Addendum No. 01

Date: April 09, 2026

Re: USOSM – Hopkin Oral Surgery
1377 E 3900 S
Salt Lake City, Utah 84124

Project No: 2025.79

1 A-0 DEMOLITION FLOOR PLAN 3/16" = 1'-0"

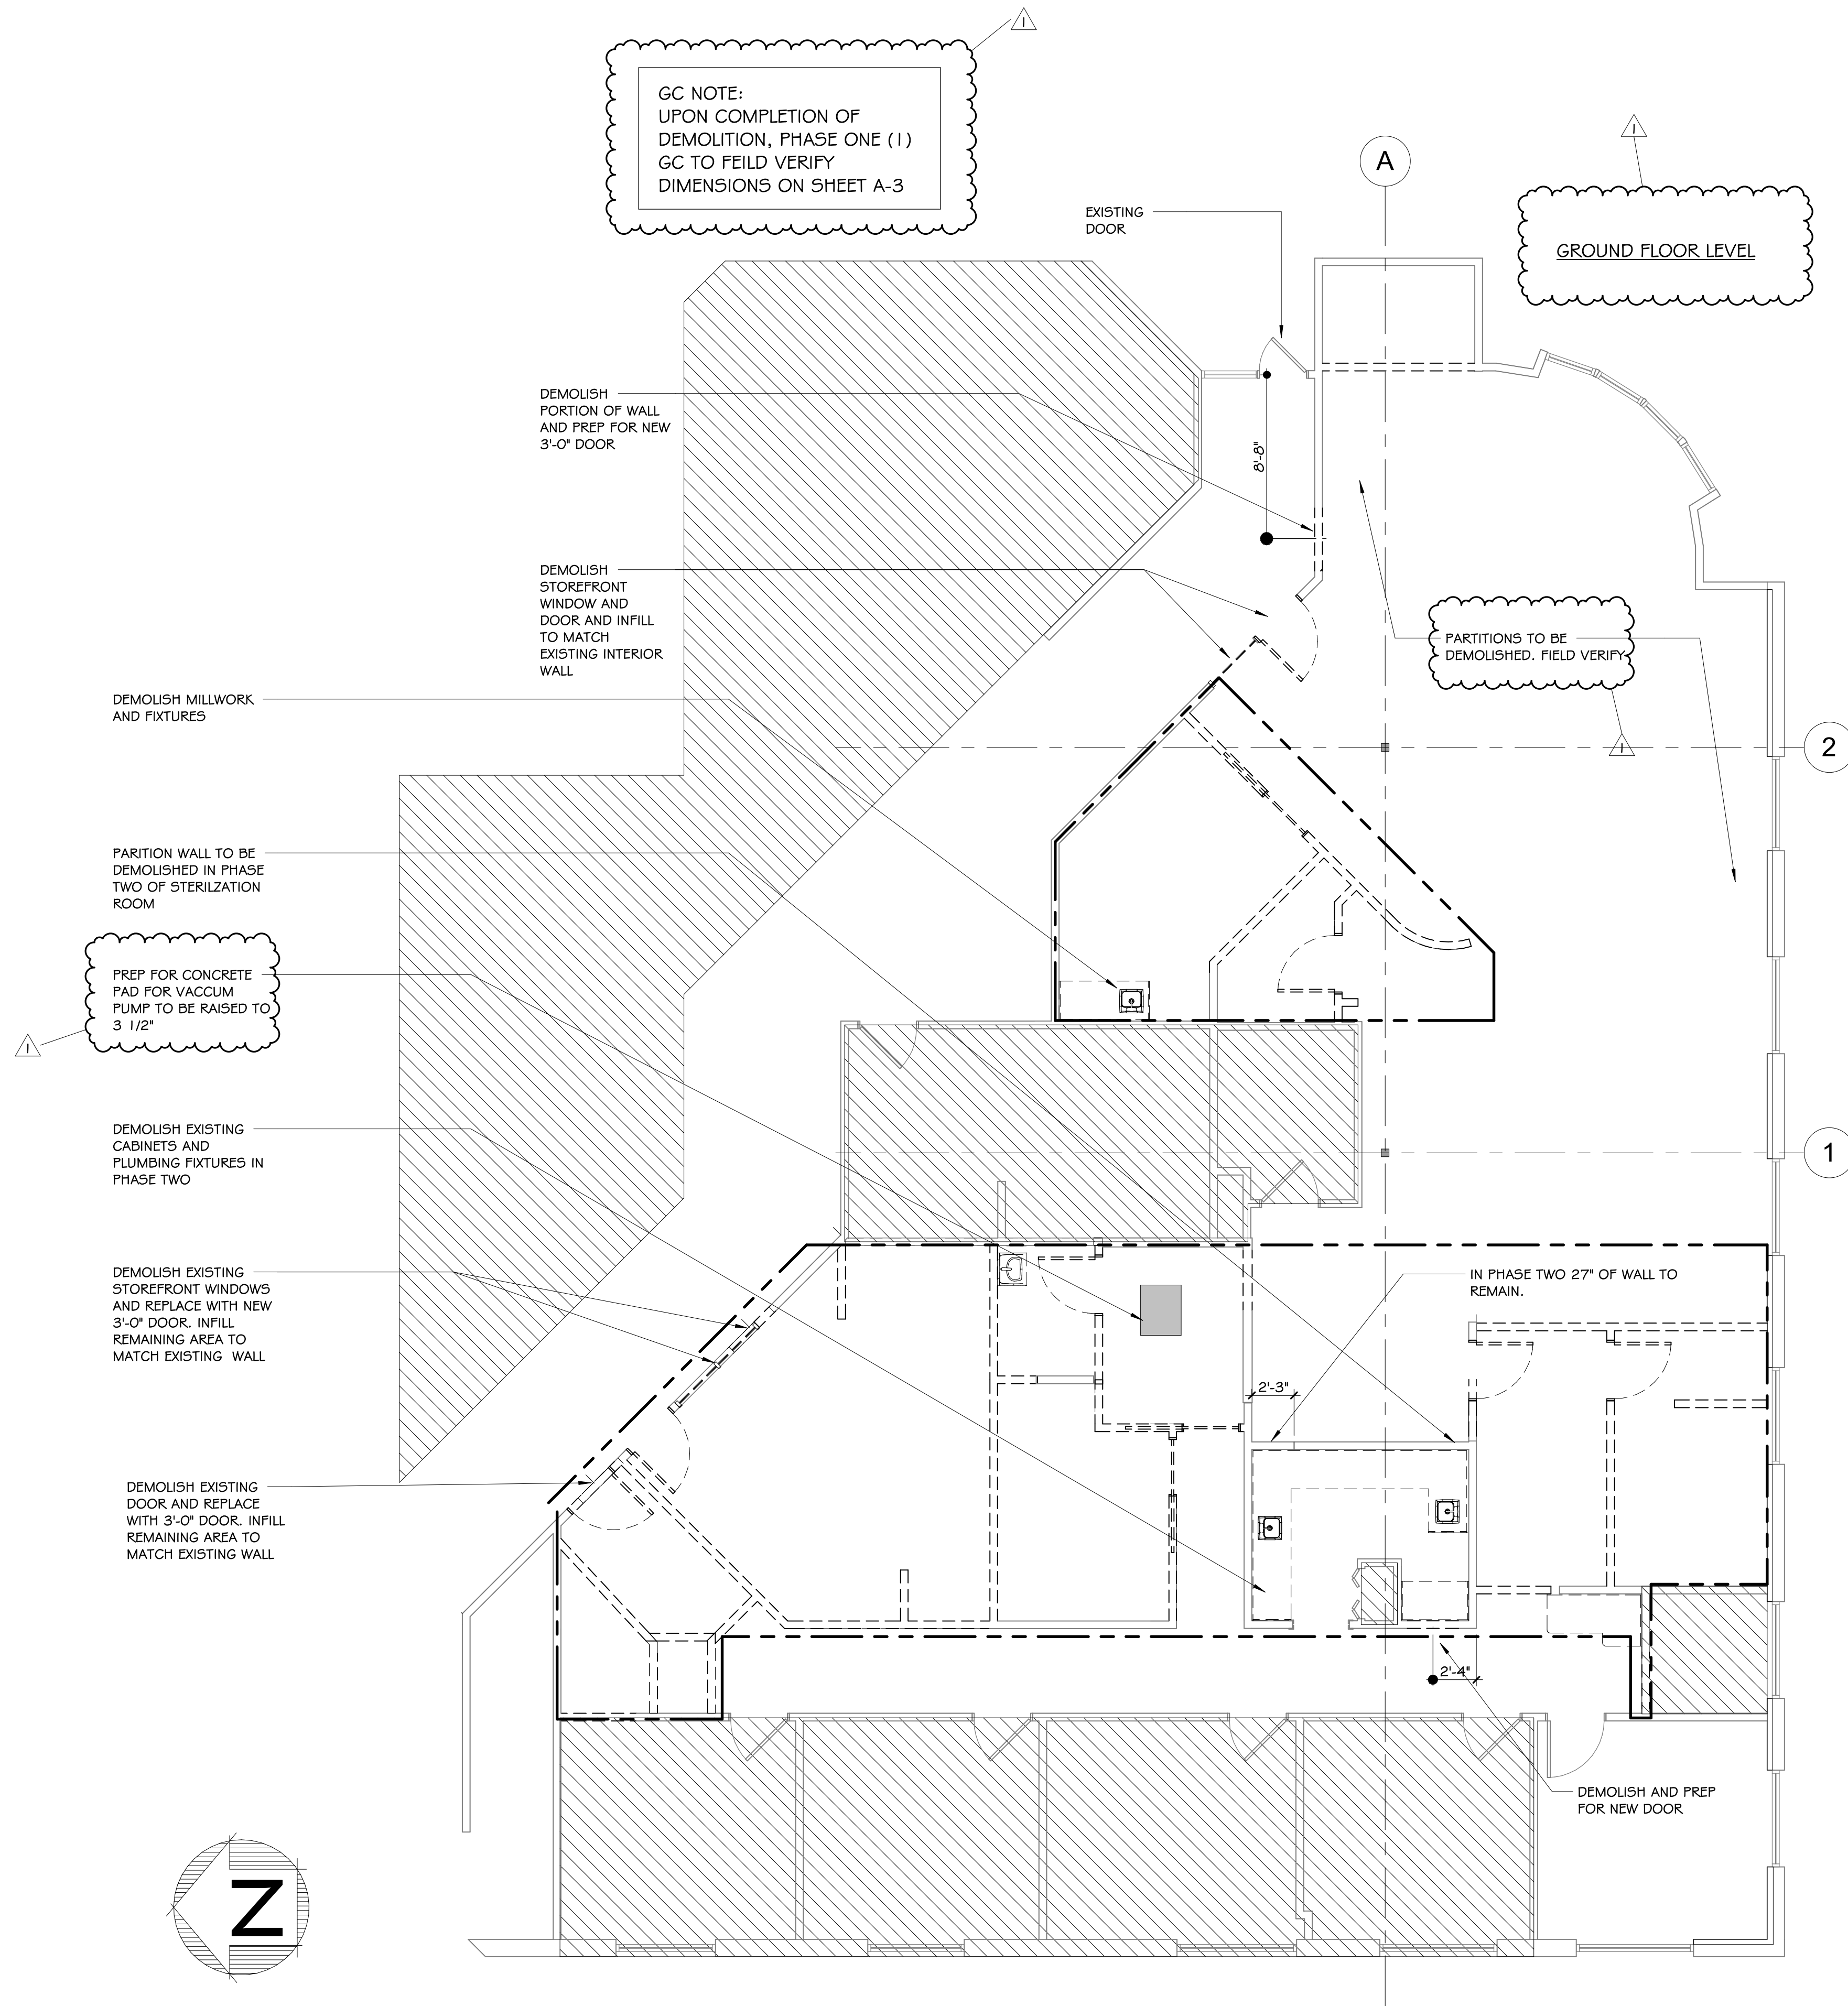
3. Revision:
Sheet A-0:
 - A. Added note to indicate a concrete pad for vacuum pump. (Architectural Clarification)
 - B. Added note to indicate which floor level for the floorplan is on. (Permit Response)

1 DIMENSIONED FLOOR PLAN 1/4" = 1'-0"

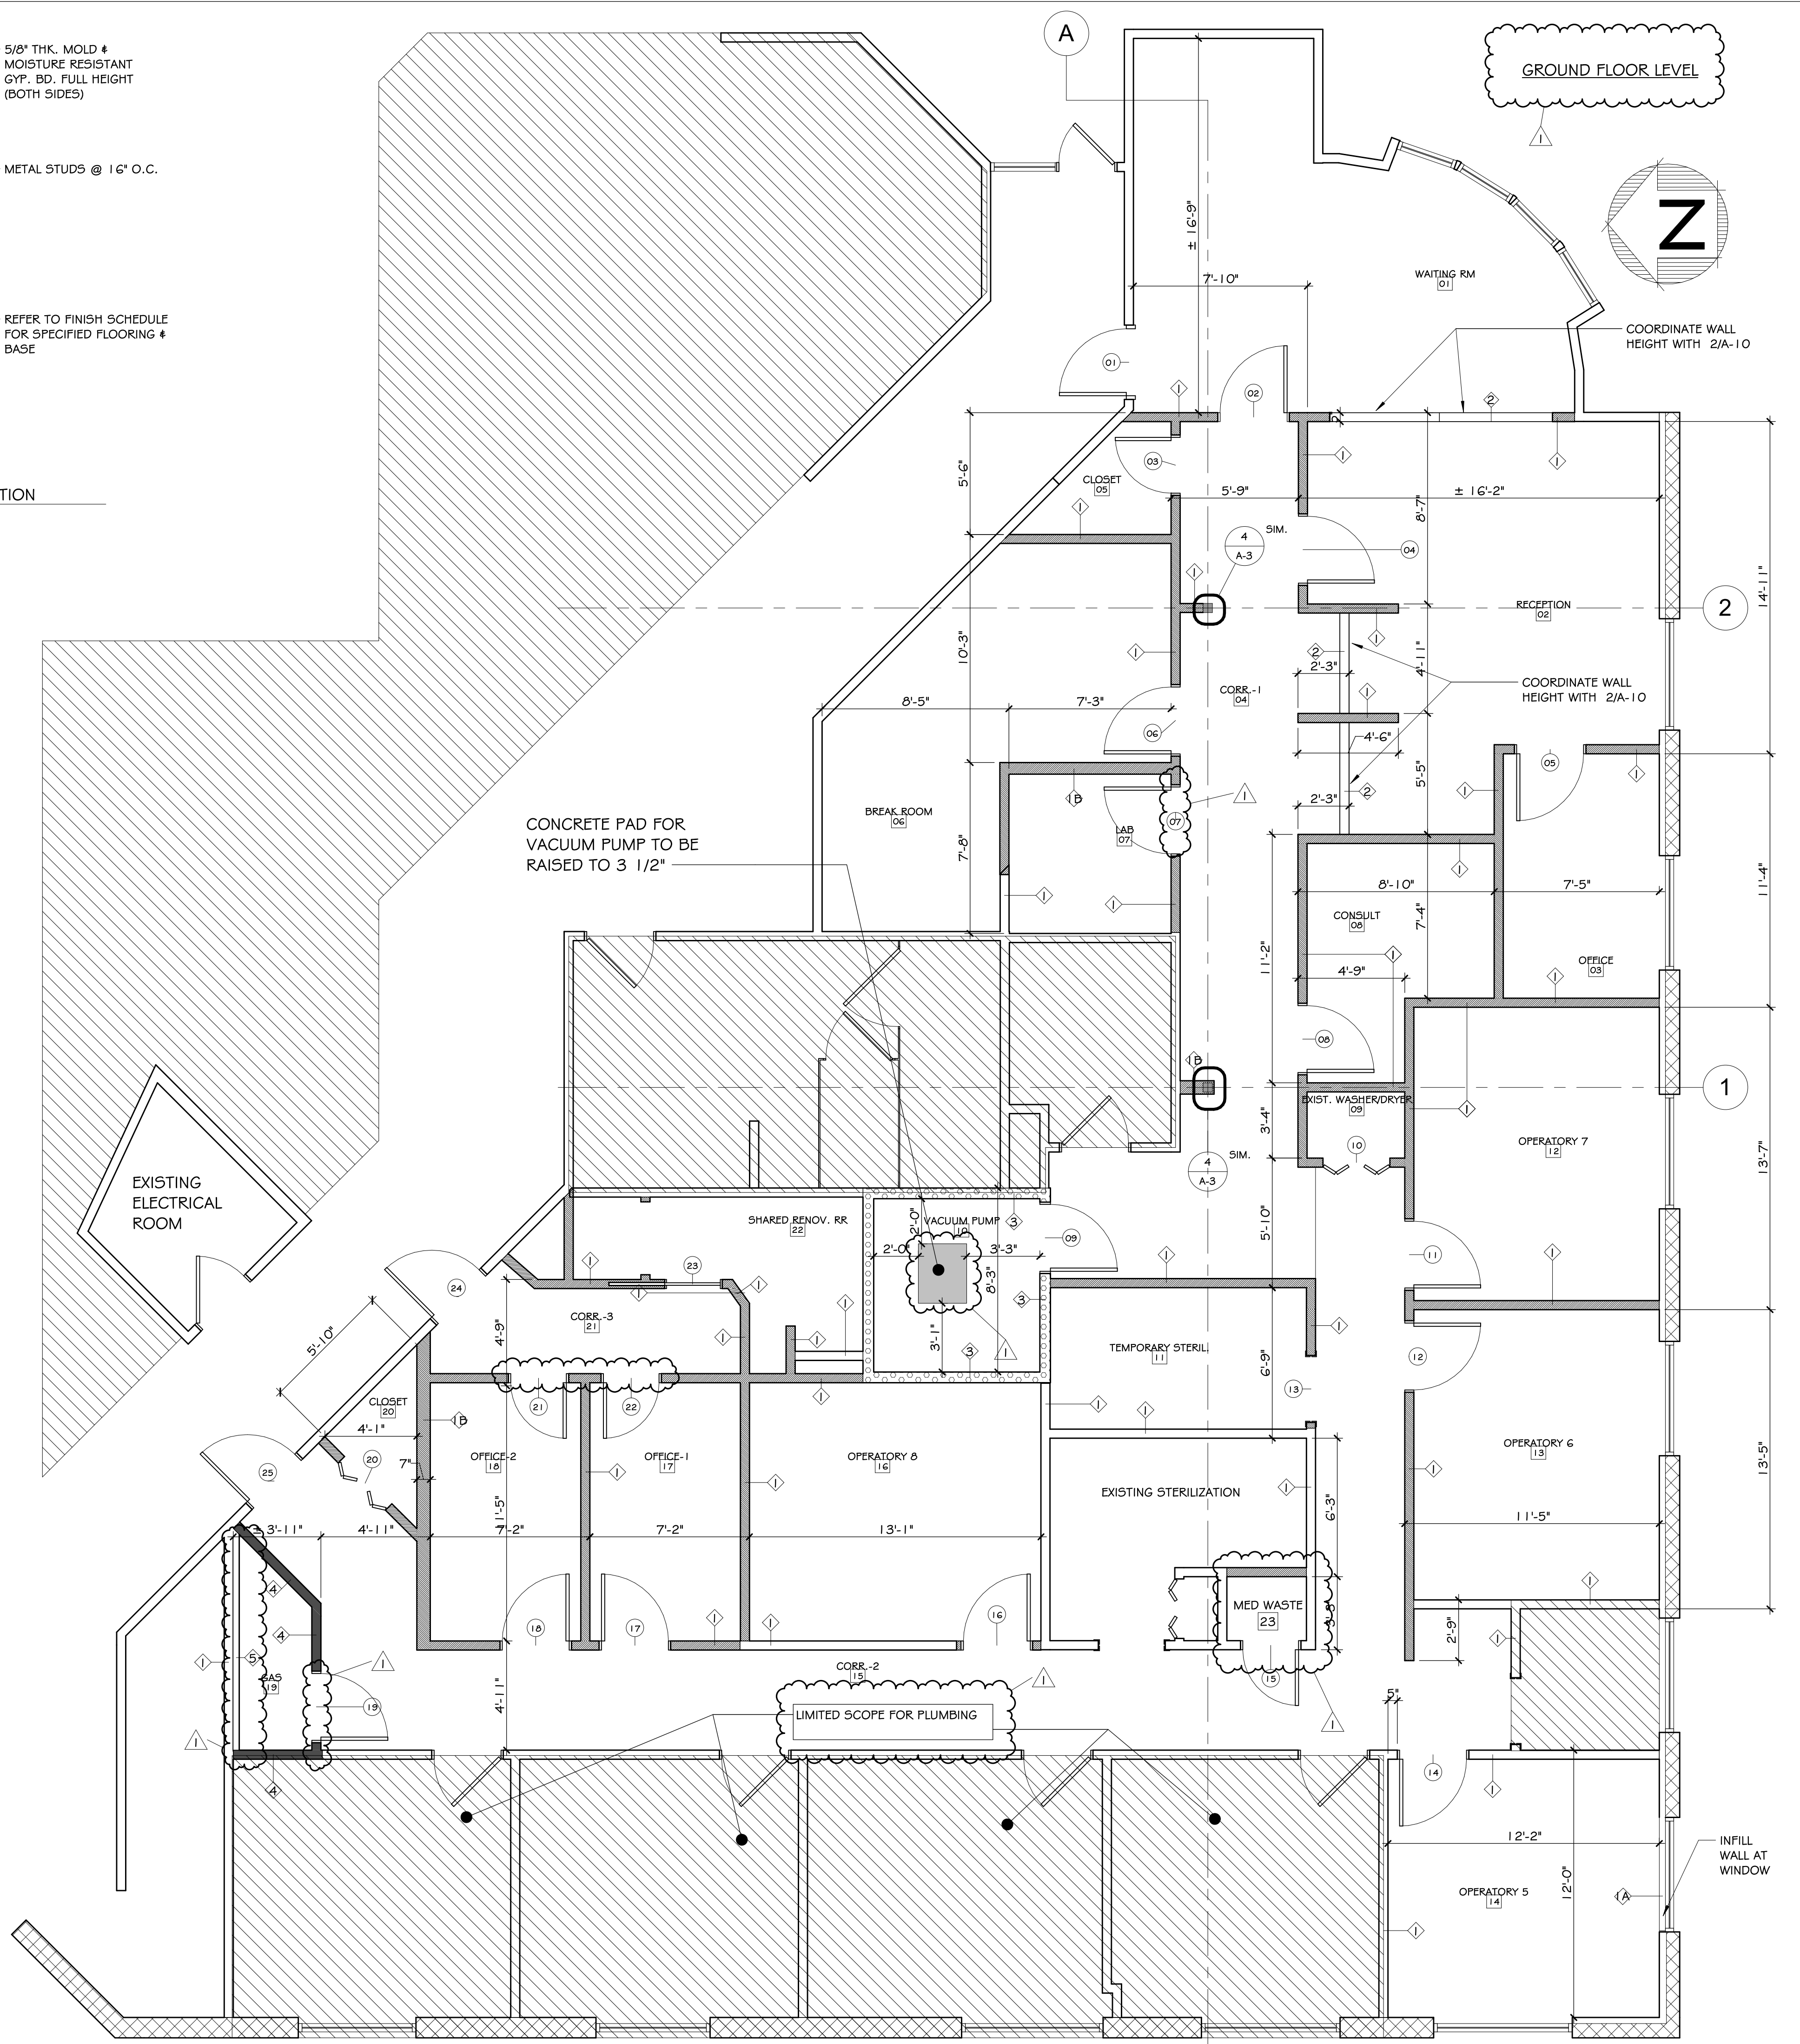
- F. Added 1hr fire rated shaft wall assembly to gas room (19).
(Architectural Clarification)
6. Revision:
Sheet A-3:
- A. Updated floor plan to show new Med. Waste room.
(Architectural Clarification)

- B. Changed door types at Med gas, lab, and the offices.
(Architectural Clarification)
 - C. Updated the wall Legend. (Architectural Clarification)
 - D. Added dimensions to the Vacuum pump raised concrete pad.
(Architectural Clarification)

- E. Removed details. (Architectural Clarification)
 - F. Updated detail 4/A-3. (Architectural Clarification)
 - G. Added note to indicate which floor level the floorplan is on.
(Permit Response)

- H. Added 1hr fire rated shaft wall assembly to gas room (19).
(Architectural Clarification)
 - I. Added note to the floor plan. (Architectural Clarification)

2 WALL SECTION - NON-RATED PARTITION
A-4 1/2" = 1'-0"

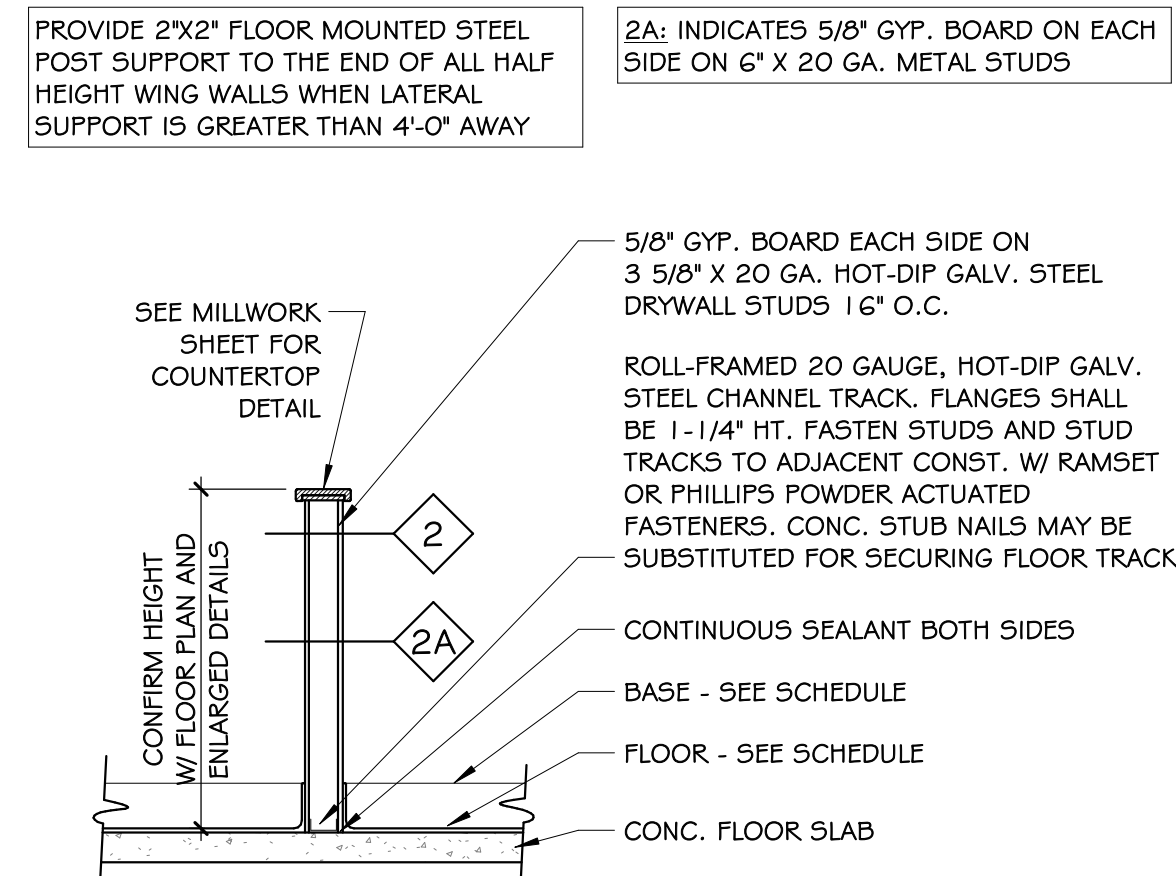
- C. Updated the wall Legend. (Architectural Clarification)
 - D. Updated details 2/A-4, 4/A-4 and 5/A-4.
(Architectural Clarification and Permit Response)

SHAFT WALL ASSEMBLY: UL DES. U415:

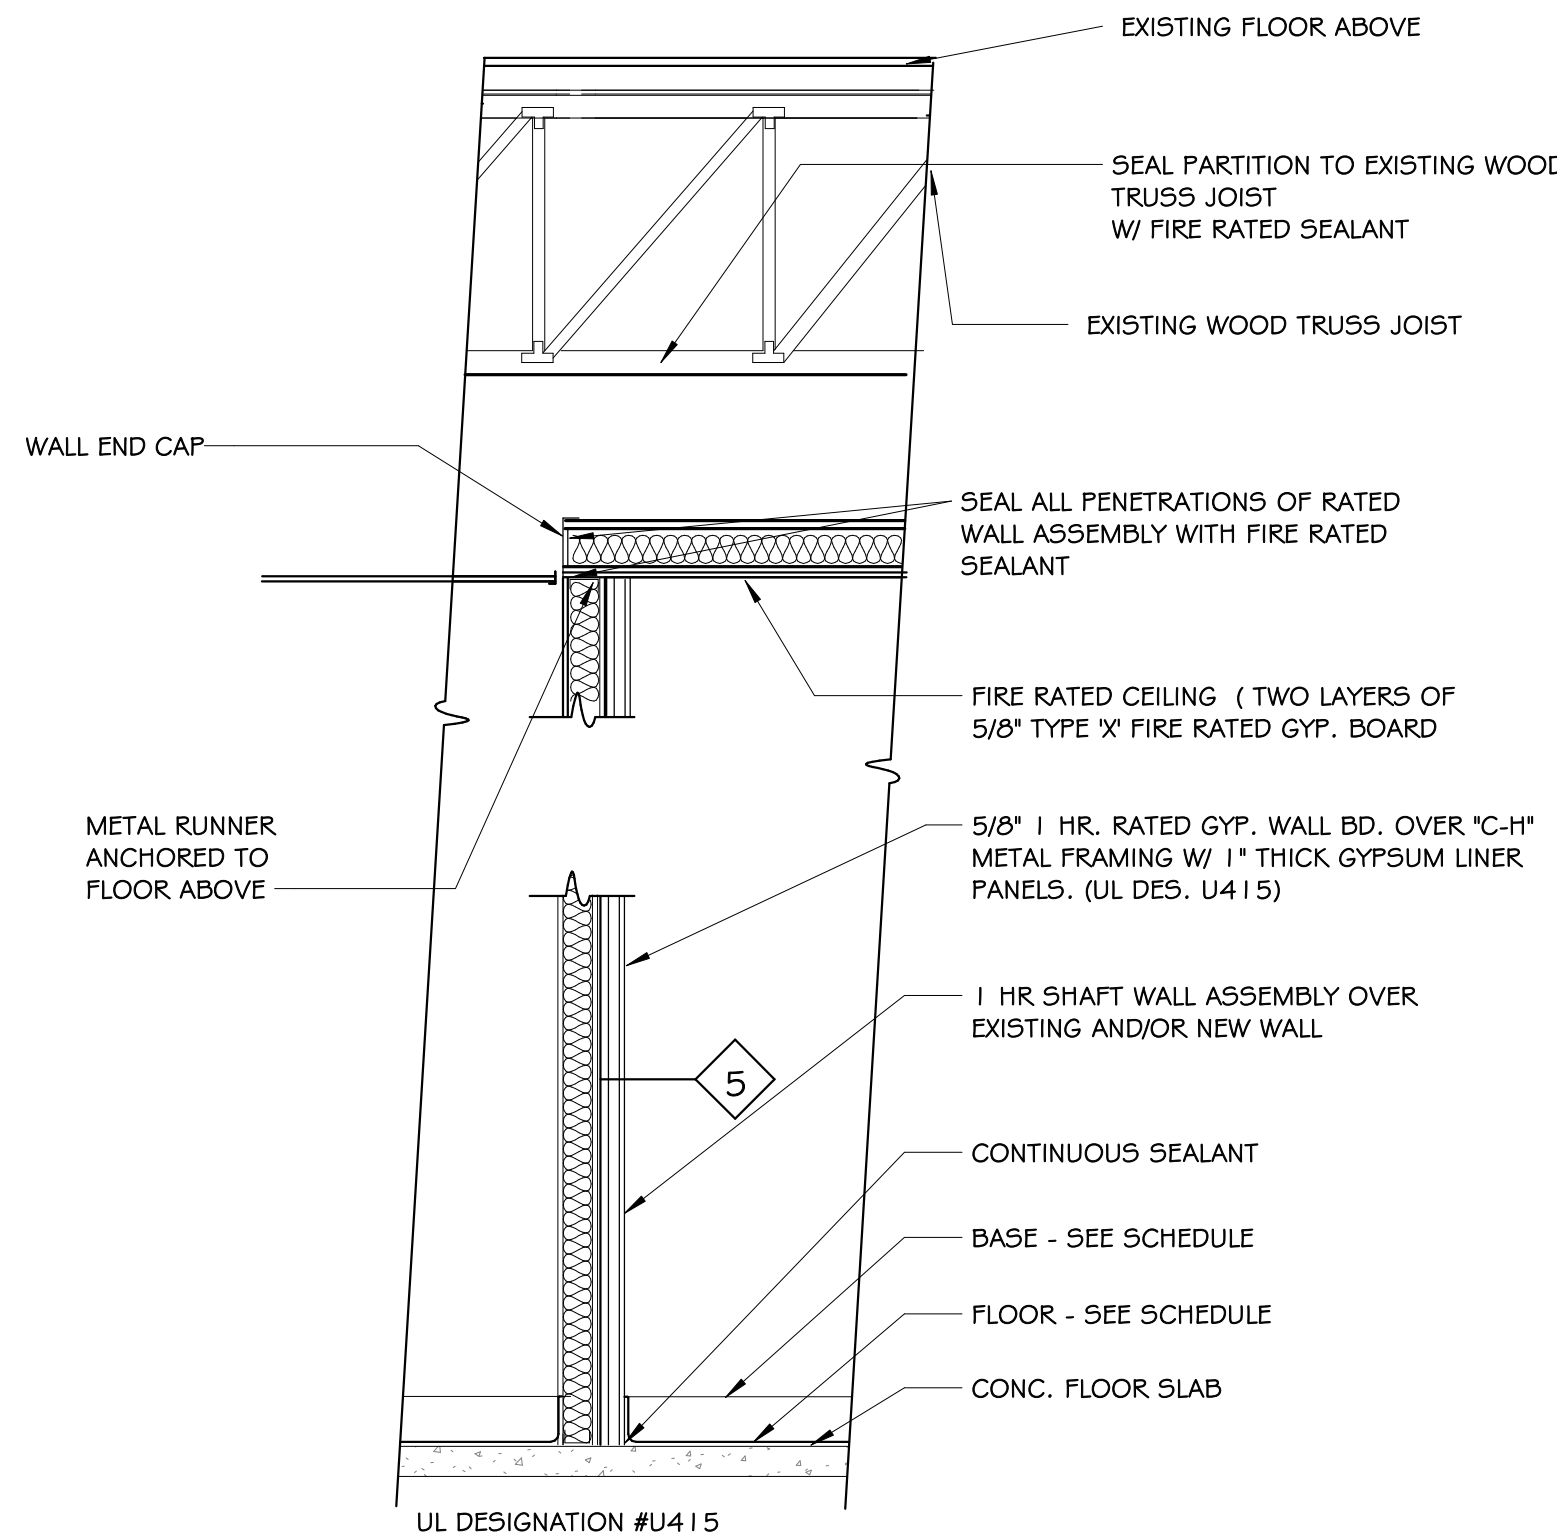
8. Revision:
Sheet A-5:
- A. Removed detail. (Architectural Clarification)
 - B. Added shaft wall assembly specifications. (Architectural Clarification)
 - C. Added wall section detail for 1 hr. fire rated shaft wall.
(Architectural Clarification)
